March 31, 1982
AW-82-21

APPLICATION FOR WITHHOLDING PROPRIETARY
INFORMATION FROM PUBLIC DISCLOSURE

SUBJECT: Response to Questions on WCAP-9561, "Bart-A1: A Computer Code for the Best Estimate Analysis of Reflood Transients" (Proprietary)

FIGURE 1 - BART MOVING AND INITIAL CONDITIONS

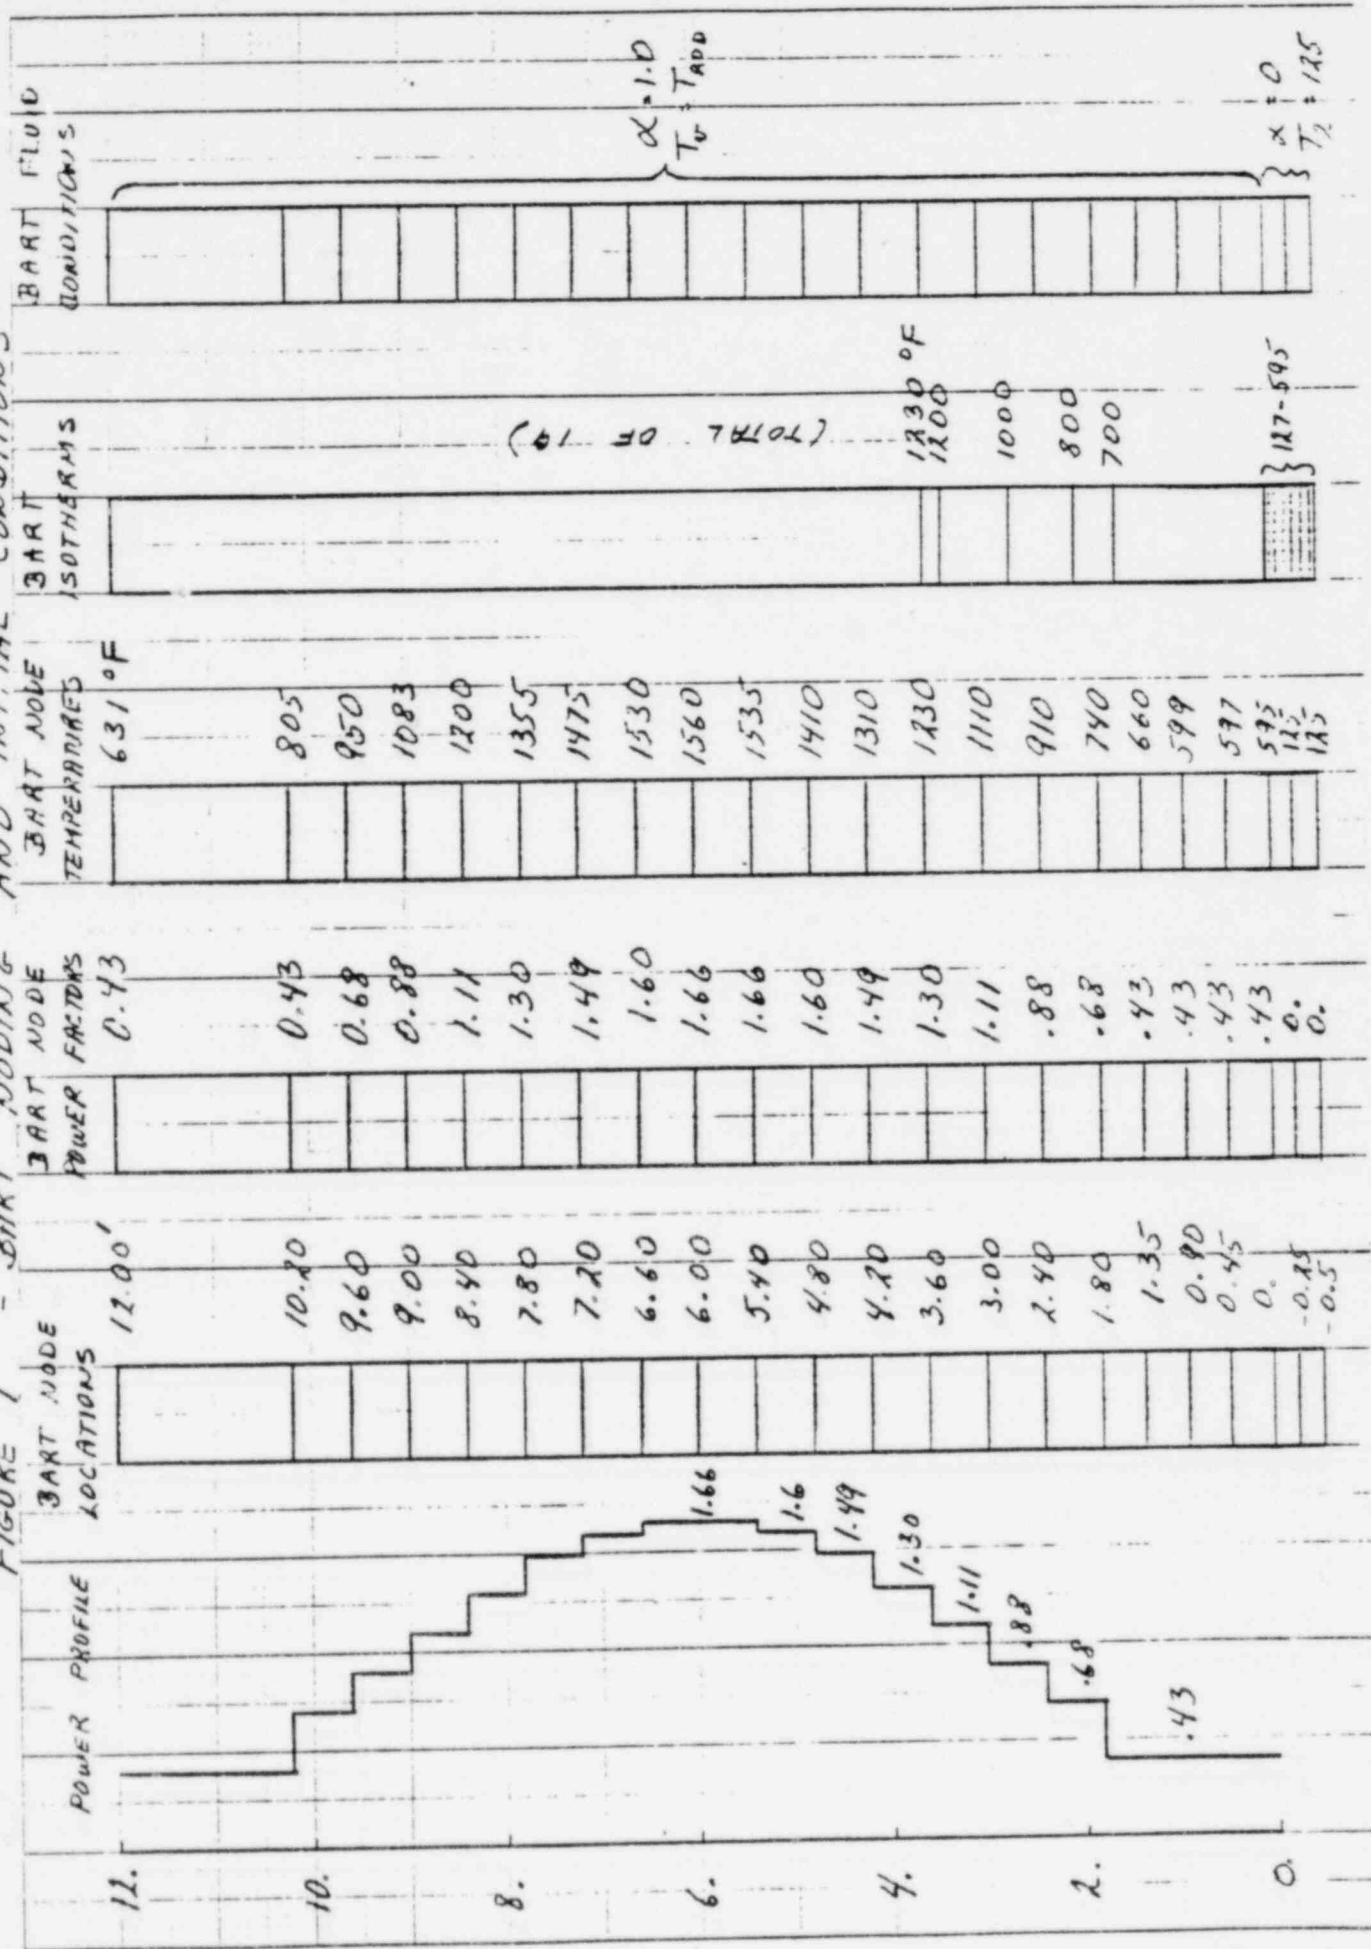
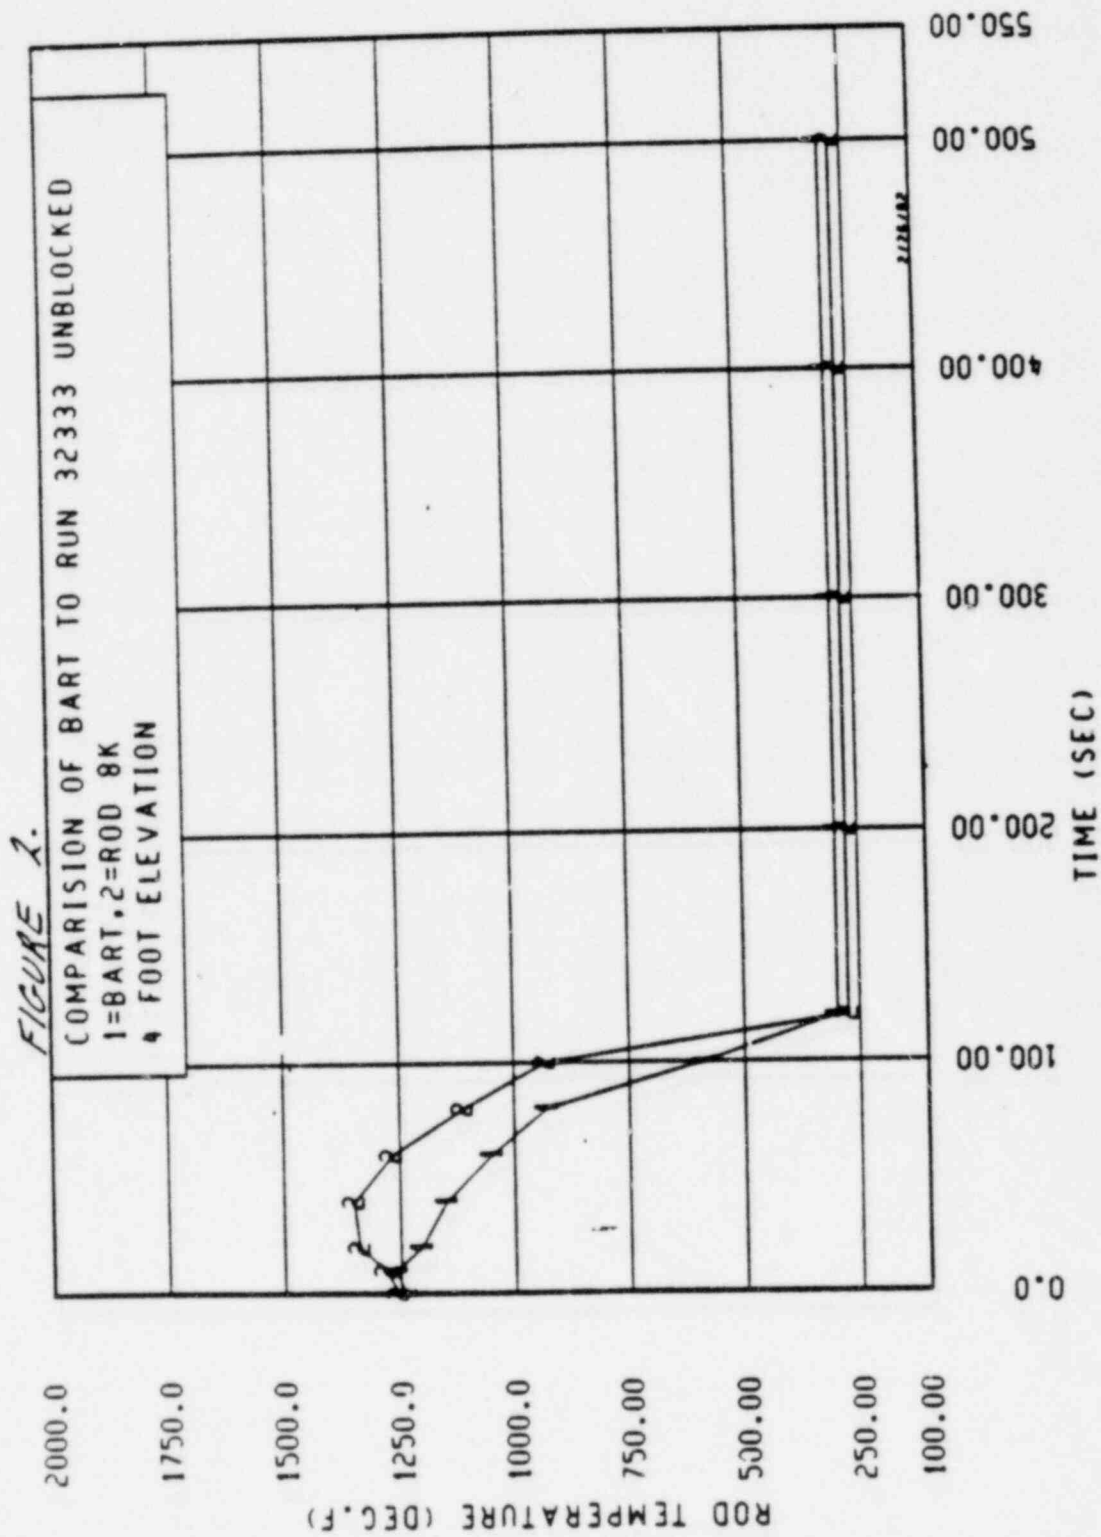
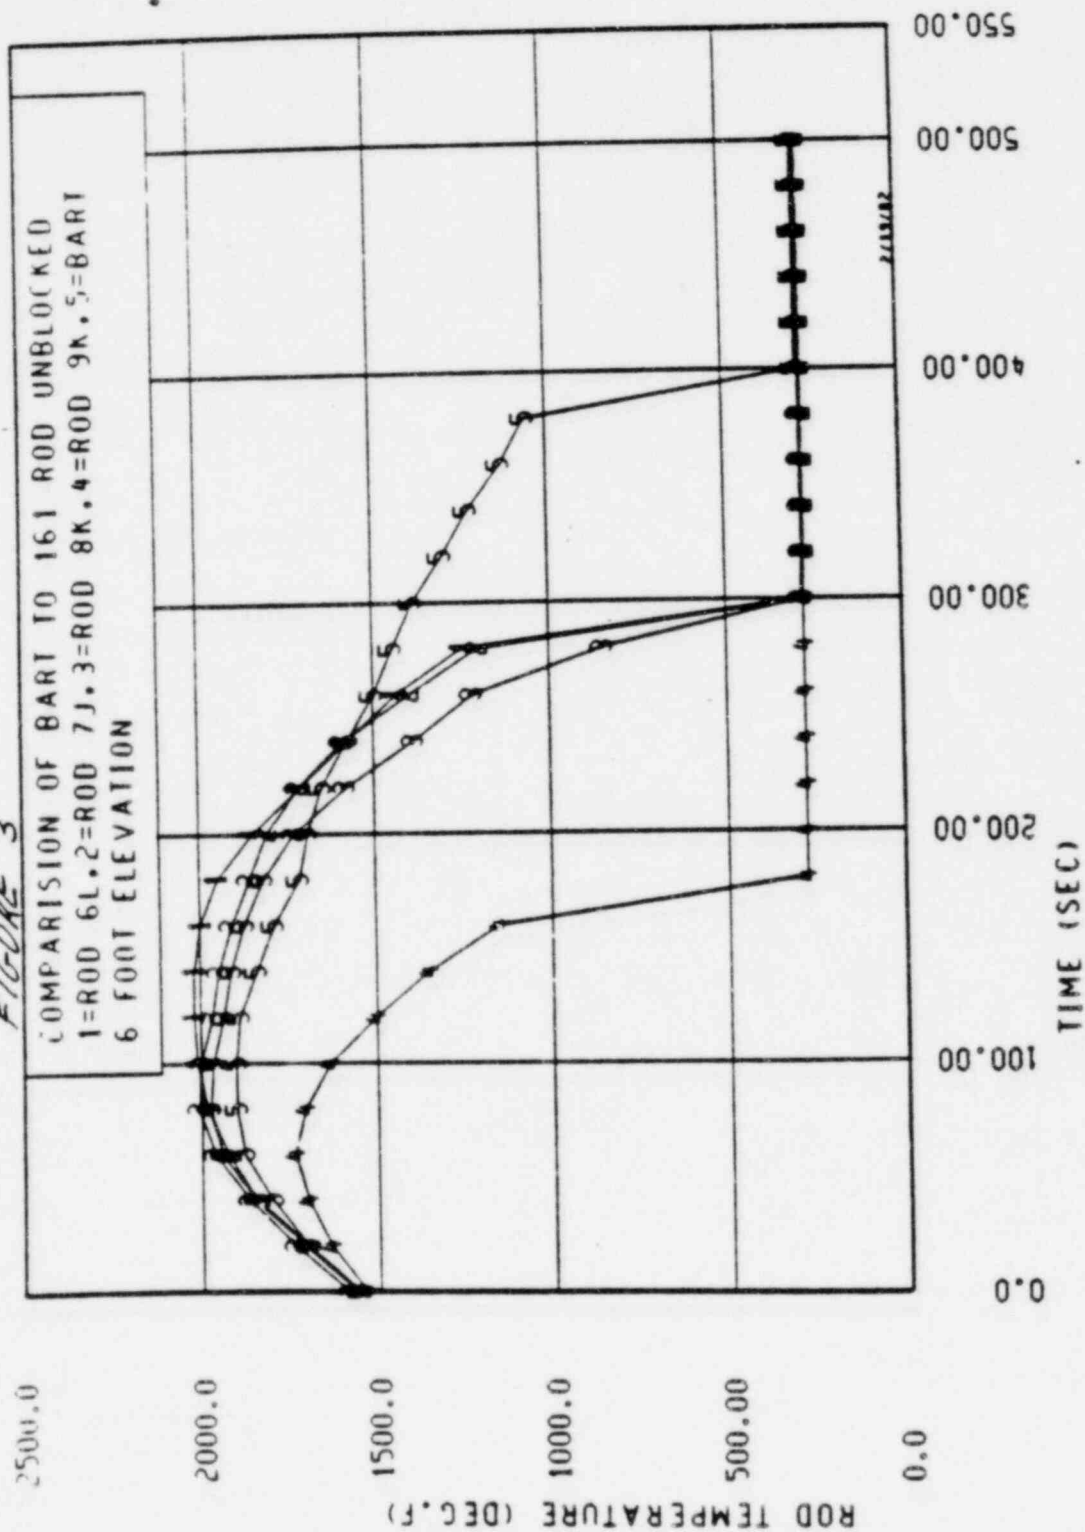
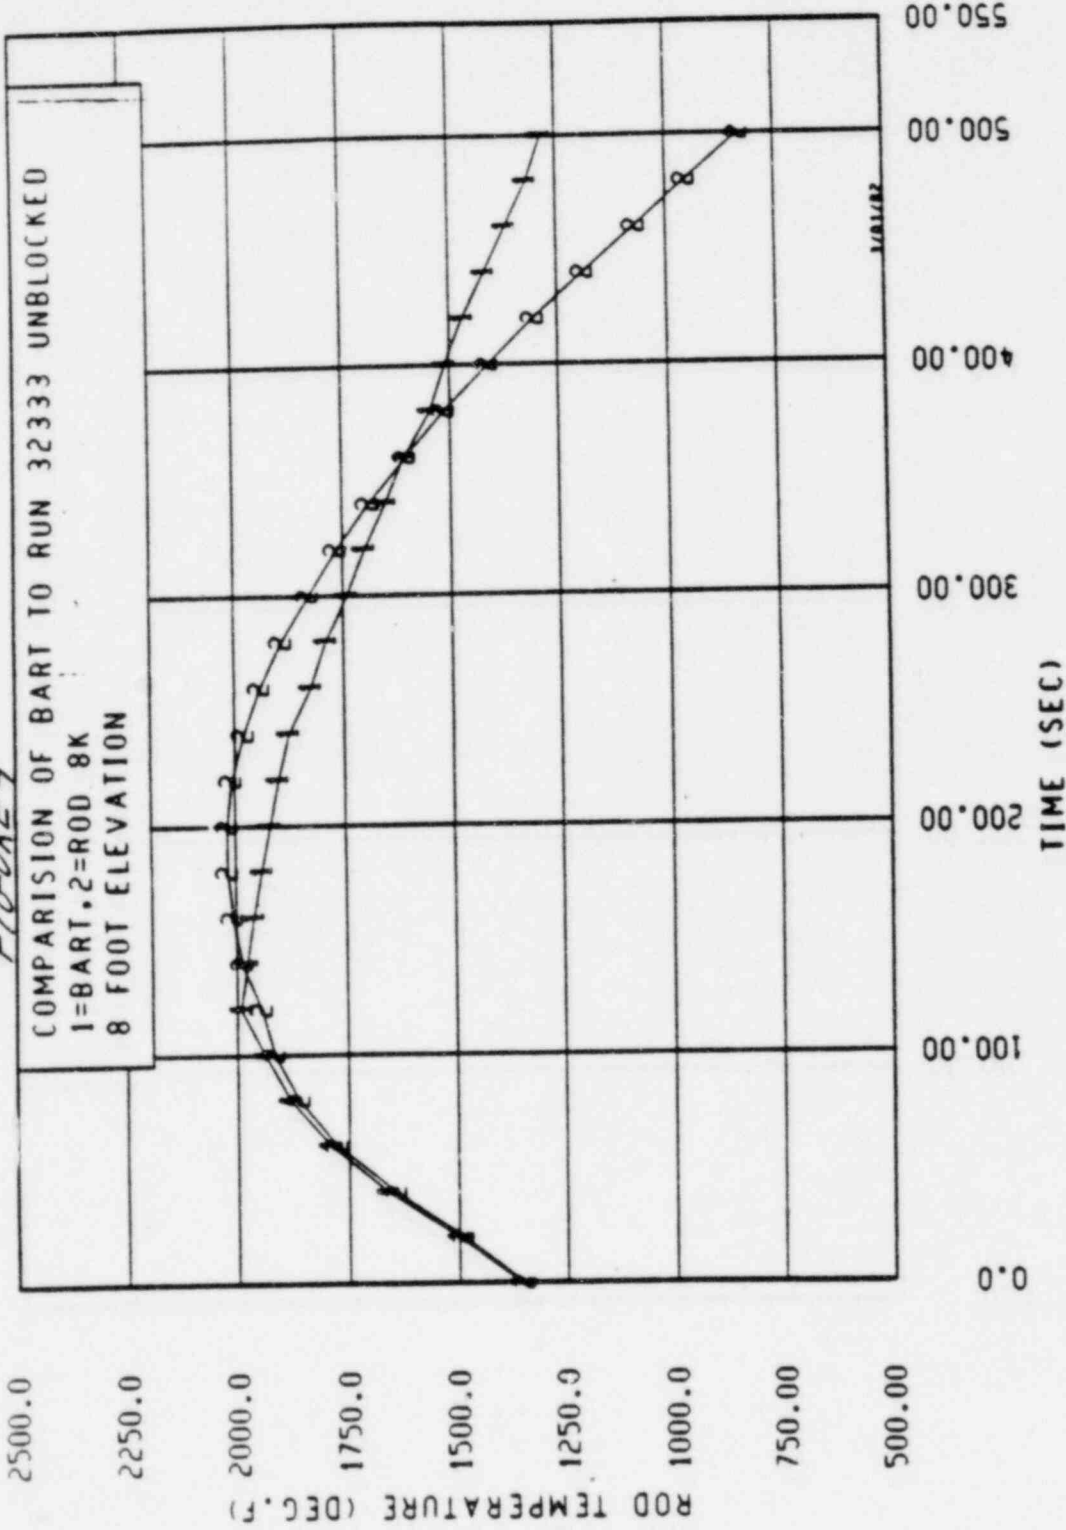
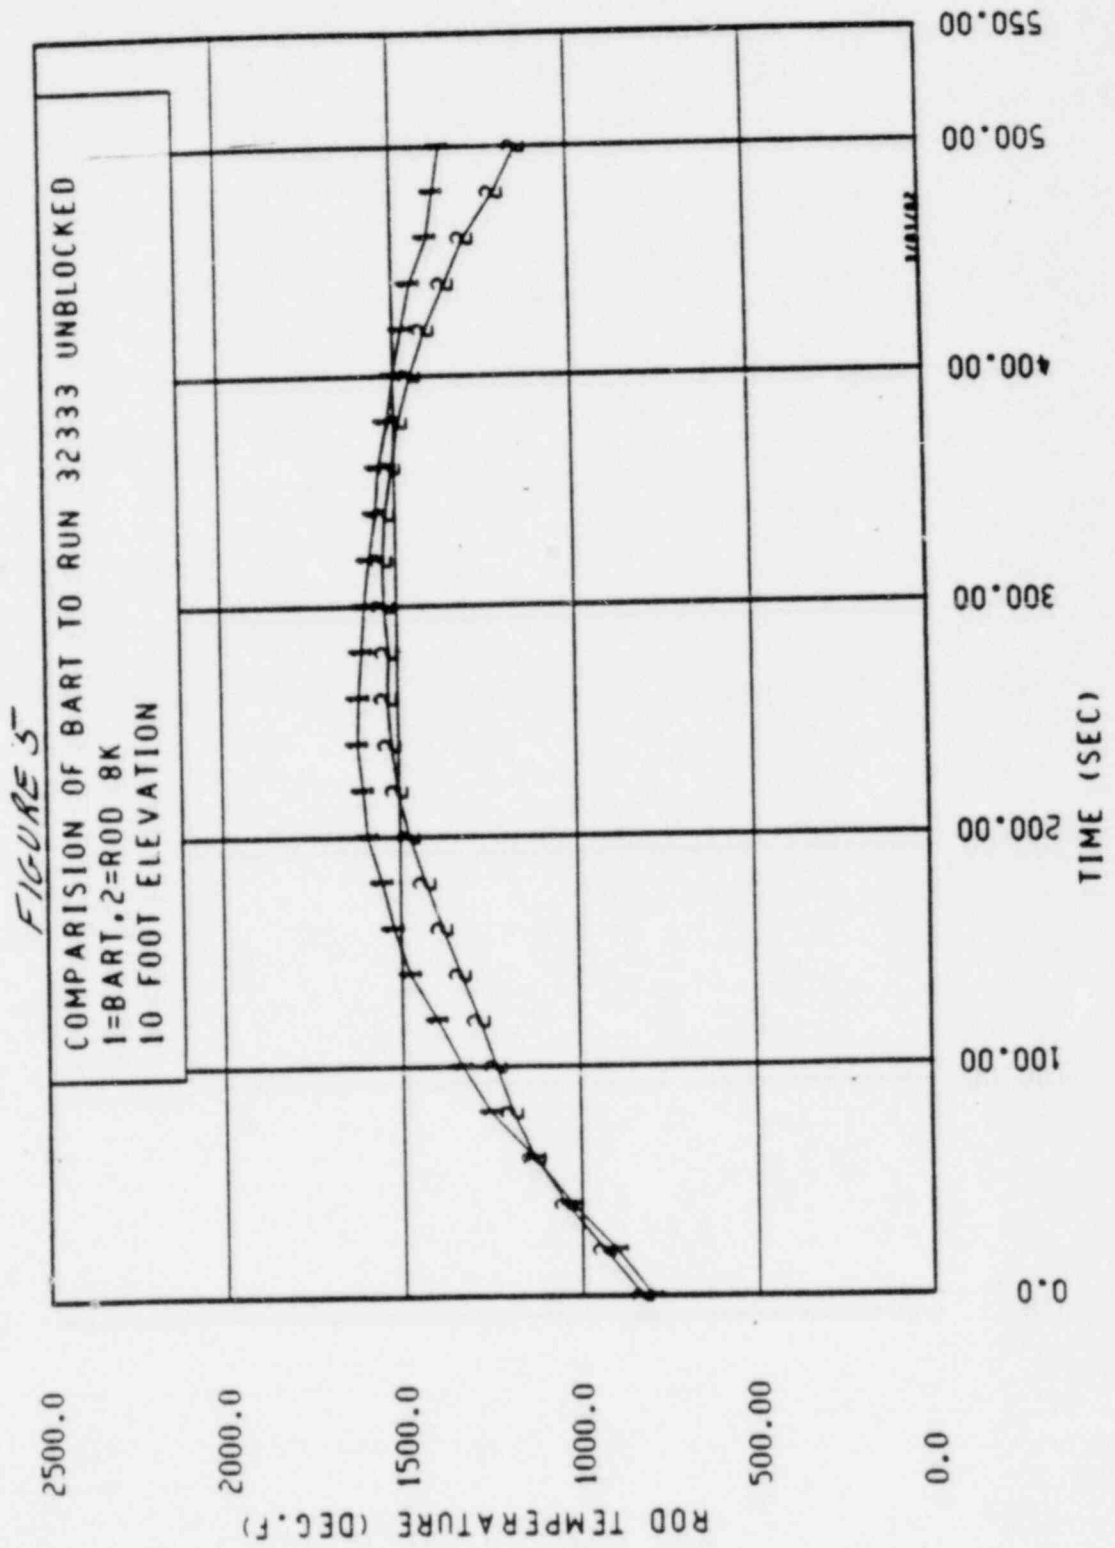
- 4.) Provide comparison calculations of the PWR FLECHT SEASET unblocked bundle, forced and gravity reflood tests 32333 and 32234. These comparisons should include but are not restricted to calculations modelling rod 6L in test 32333 and 6K in test 32235; also rods 7J, 8K, 9K and 11E for both tests. Include the input data in the calculations summary.

Table 1 lists the initial and boundary conditions for tests 32333 and 32235. Figure 1 shows the noding scheme, power profile, and initial temperature profile used in the BART calculation. Figures 2 - 5 compare BART predicted clad temperatures to the measured temperature of the rods listed above for test 32333 wherever these measurements are available. A more representative comparison is shown in Figures 6 - 9, where the BART prediction is compared to the mean temperature of all rods more than two rows away from the test housing and dead rods. Similar comparisons are shown in Figures 10 - 13 and 14 - 17 for test 32235. It can be seen that agreement is quite good for these stepped flooding rate tests.
